STAFF RECOMMENDATION

1704 Shelby Avenue

June 16, 2021

Application: New Construction—Addition

SITE PLAN AND
 DEMOLITION PLAN

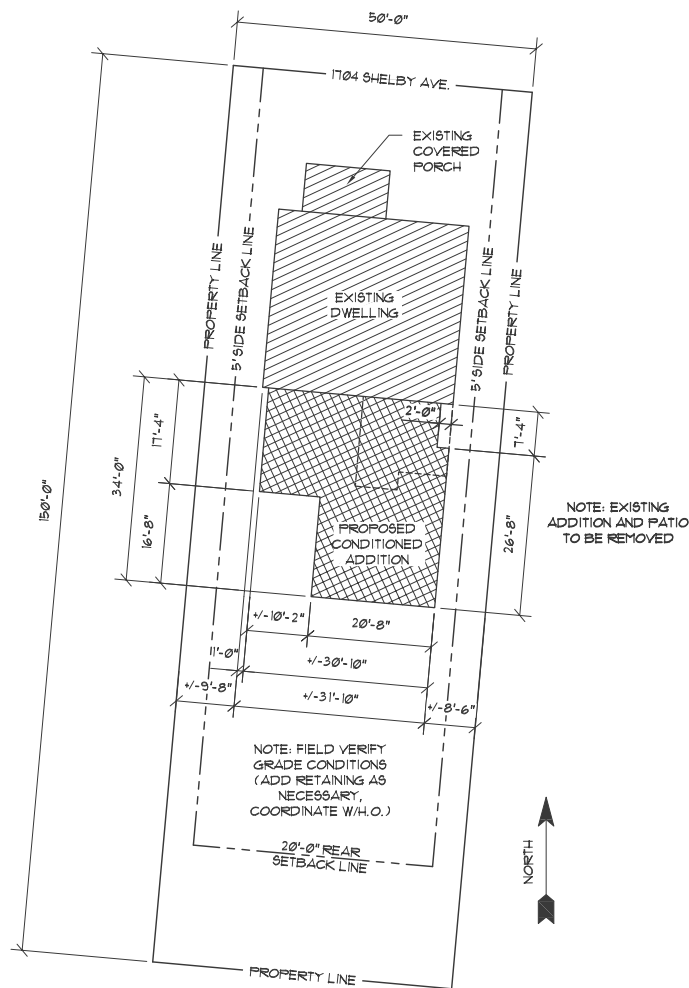
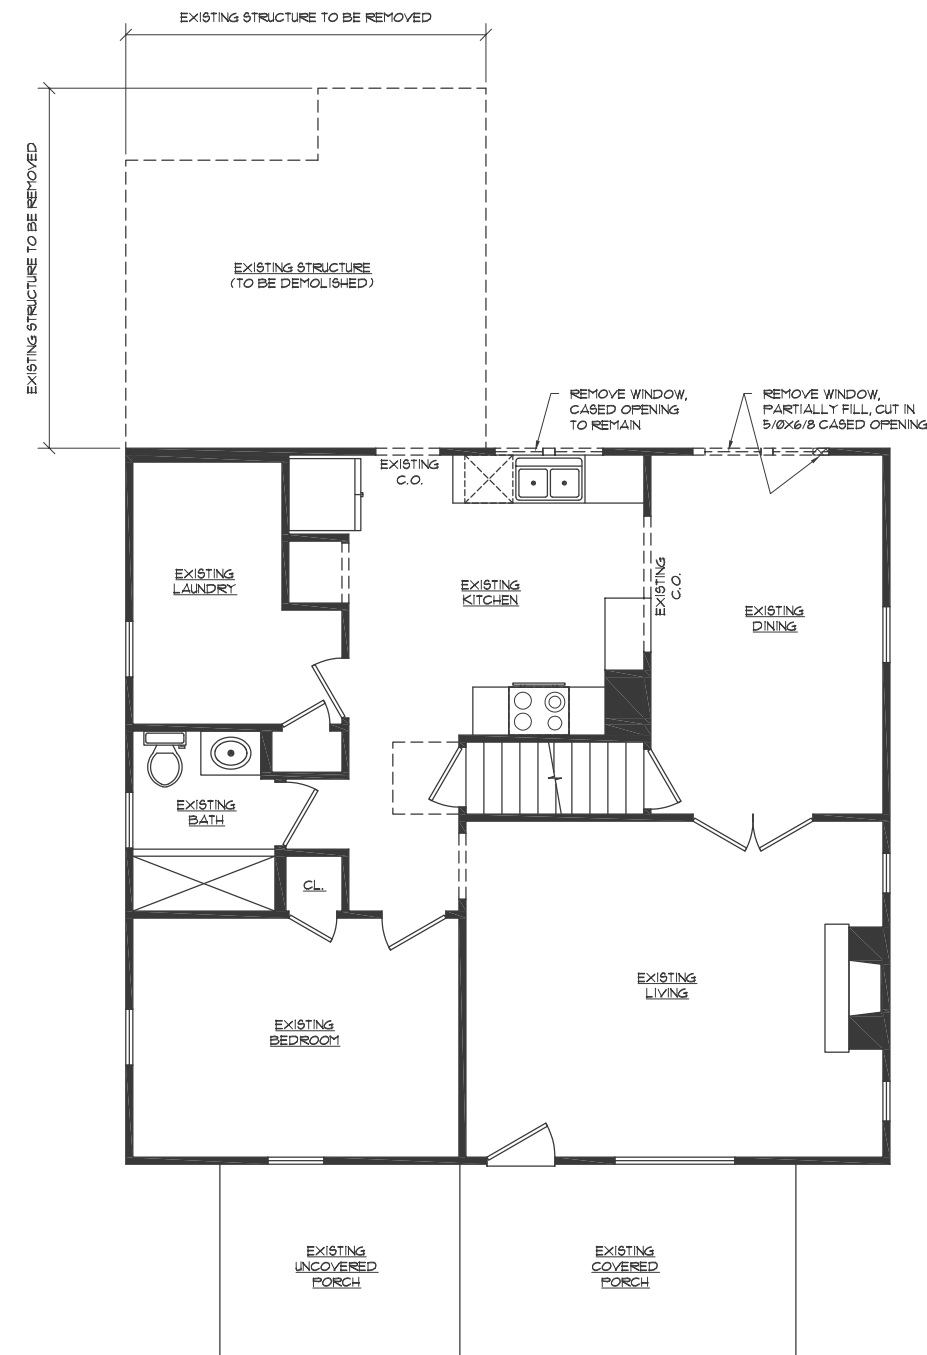
Siting and Setback: The addition is situated at the rear of the house and meets all base zoning setbacks. It will be about ten feet (10') from the right side property line and nine feet (9') from the left side property line. It will be over sixty feet (60') from the rear property line.

Staff finds the proposed siting setbacks to meet Section VI.C. of Part I and the Lockeland Springs-East End chapter of Part II. of the consolidated design guidelines for the turn-of-the-century neighborhood conservation zoning overlays

EXTERIOR
ELEVATIONS

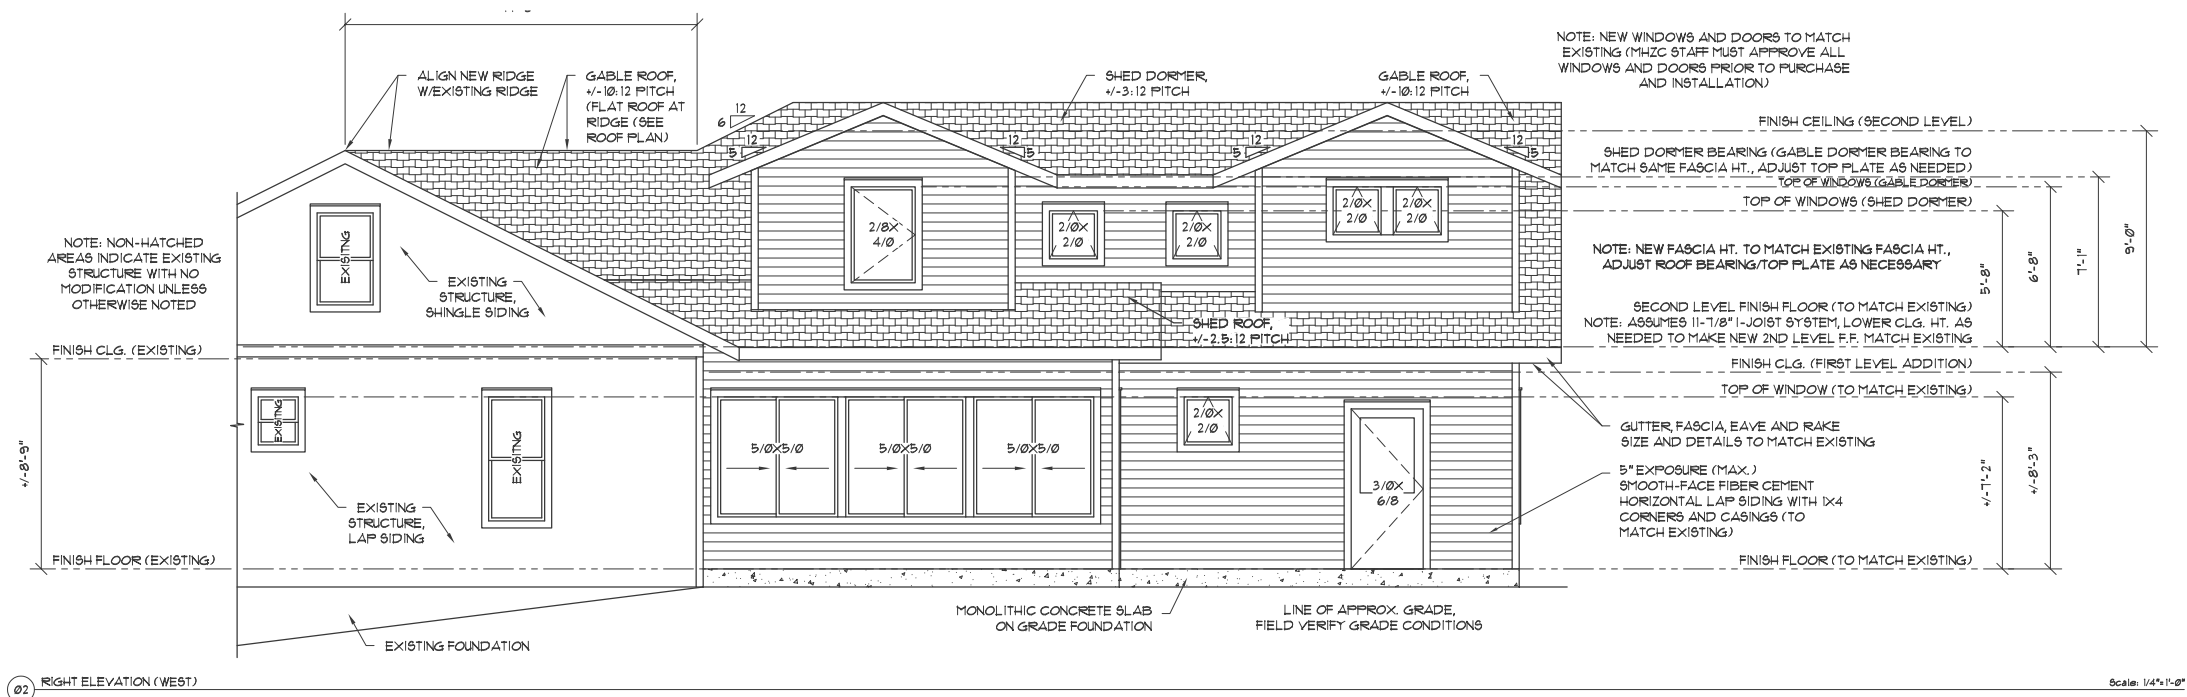
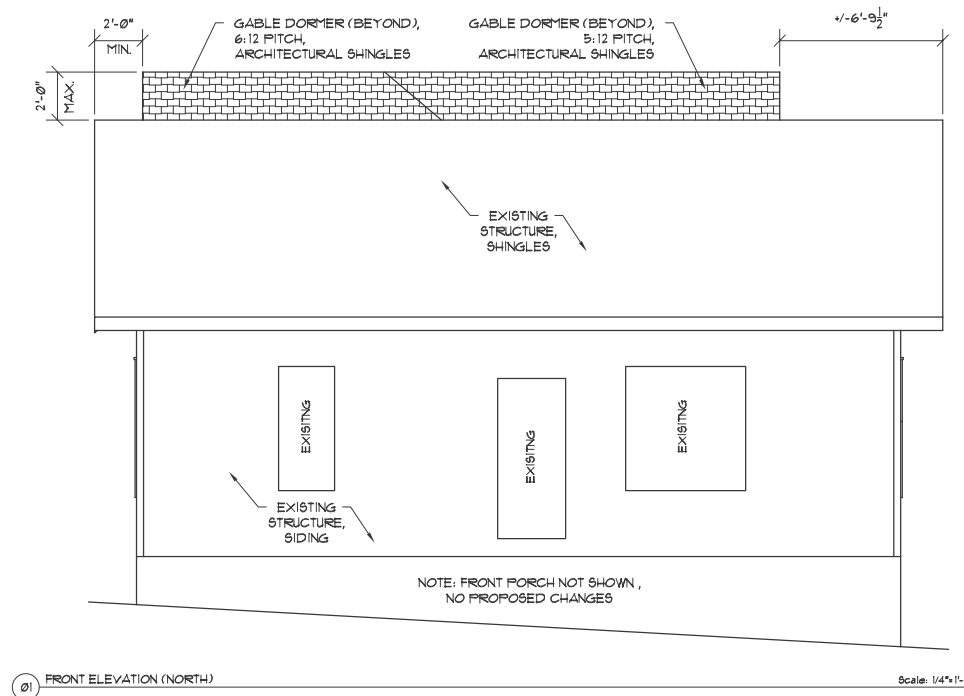
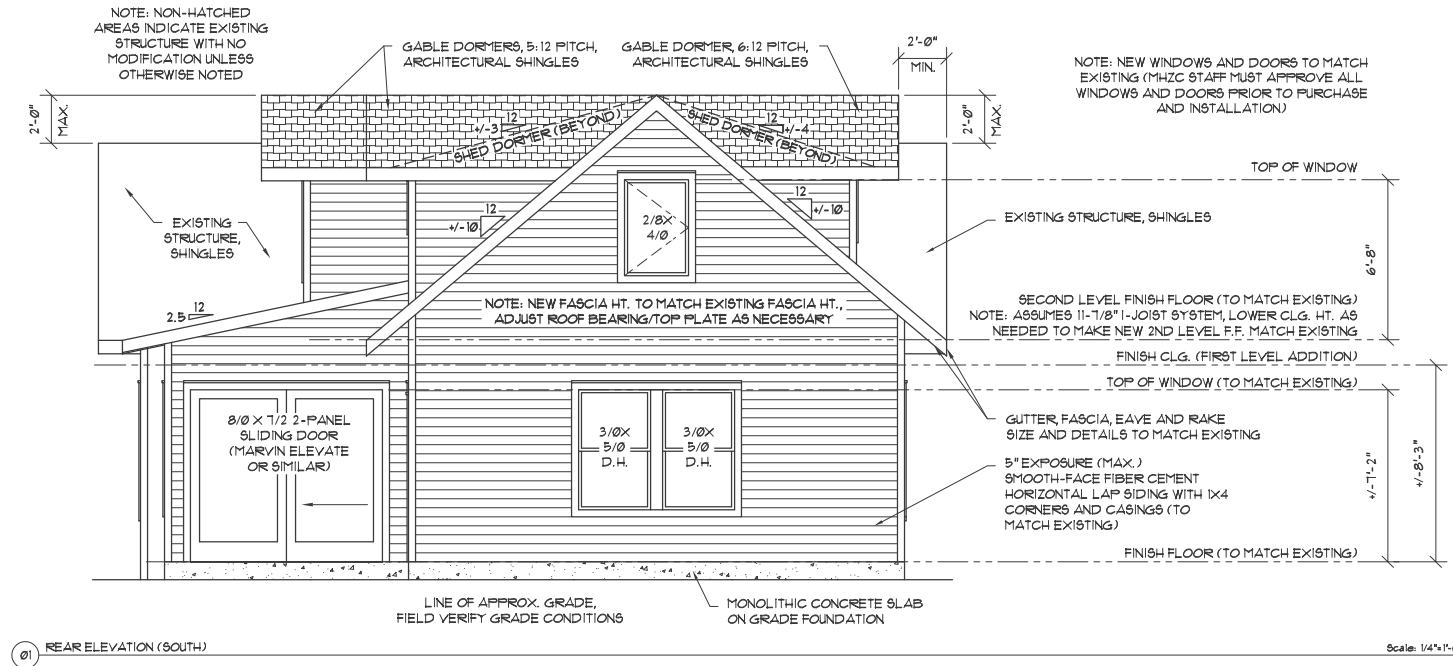
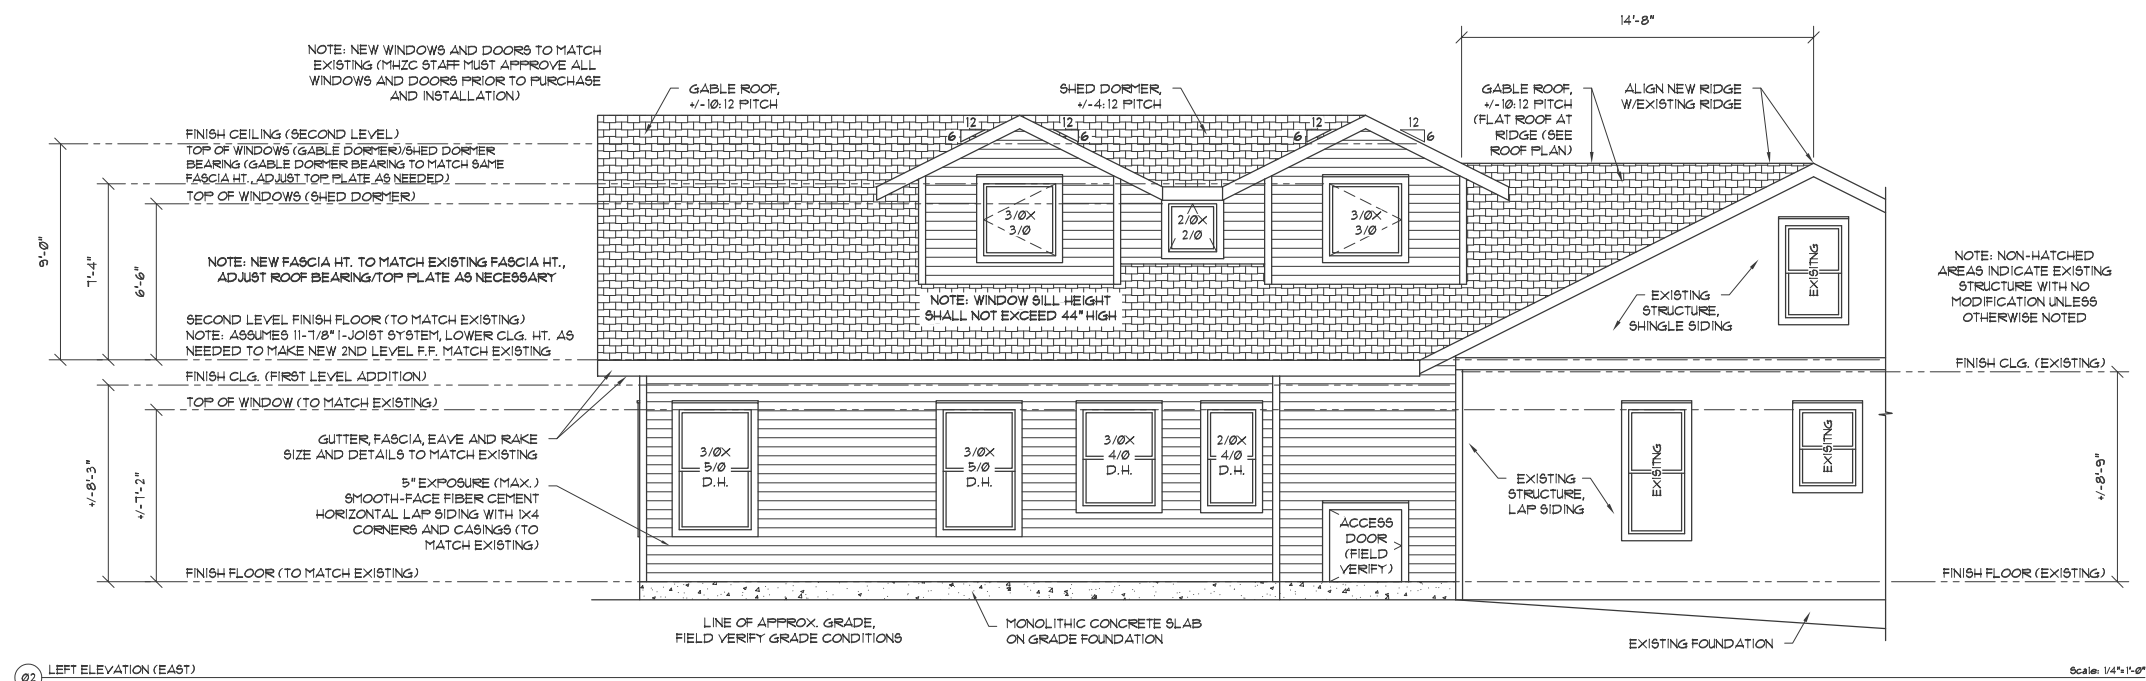
Height & Scale: The addition is inset from both back corners of the historic house. On the right side, the addition is inset one foot for its entire depth. On the left side, the addition is inset two feet (2') for a depth of seven feet, four inches (7'4"), after which it steps back out to match the width of the house. The addition will have a footprint of approximately eight hundred and sixty square feet (860 sq. ft.). By comparison, the historic house's footprint is approximately one thousand and fifty square feet (1050 sq. ft.). The addition will have a one-and-a-half story scale, which matches the scale of the historic house. Its eave and foundation heights match those of the historic house. The addition will extend two feet (2') taller than the historic house, which is permitted under the design guidelines since the taller portion is inset two feet (2') from the side walls of the historic house. Overall, staff finds the height and scale to be appropriate to the historic house.

Roof form: The main roof form is a rear facing gable with a 10/12 pitch. The project includes dormers that are inset appropriately. Although the right side dormer is long, it is inset approximately eight feet, six inches (8'6") from the side wall of the historic house and therefore will not be highly visible.

Proportion and Rhythm of Openings: No changes to the window and door openings on the existing house were indicated on the plans. The windows on the proposed addition are all generally twice as tall as they are wide, thereby meeting the historic proportions of openings. The windows in the right side dormer are square, but because the dormer is inset so much and not easily seen from the street, staff finds them to meet the design guidelines. There are no large expanses of wall space without a window or door opening.
